GROWPAD

SITE VISIT REPORT

PROJECT: No. 2124

I was engaged by Main Uddin to provide an Opinion of Exemption from Planning Control on the development at his property at No.20 Monastery Gate Copse, Dublin 22, D22 HE24.

Figure No.3. Exempted Development and Existing Rear Elevation with original protrusion.

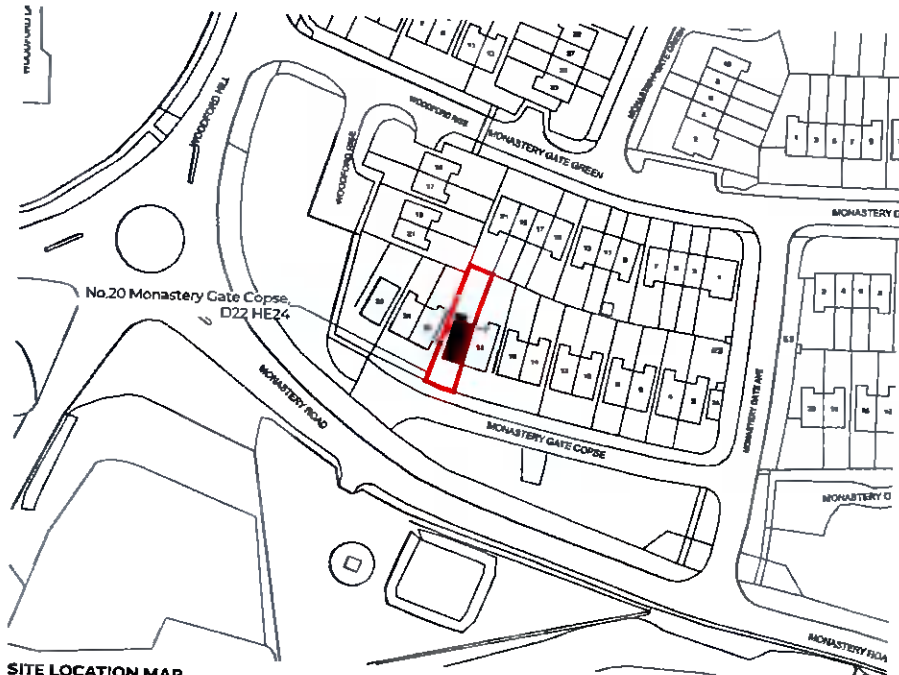
During the assessment it was not possible to accurately measure the dimension of the installed ridge timber member, however, the owner was advised to keep the finalised roof structure, at a height that should not exceed the existing roof height of the original protrusion, as shown in Fig. No. 3
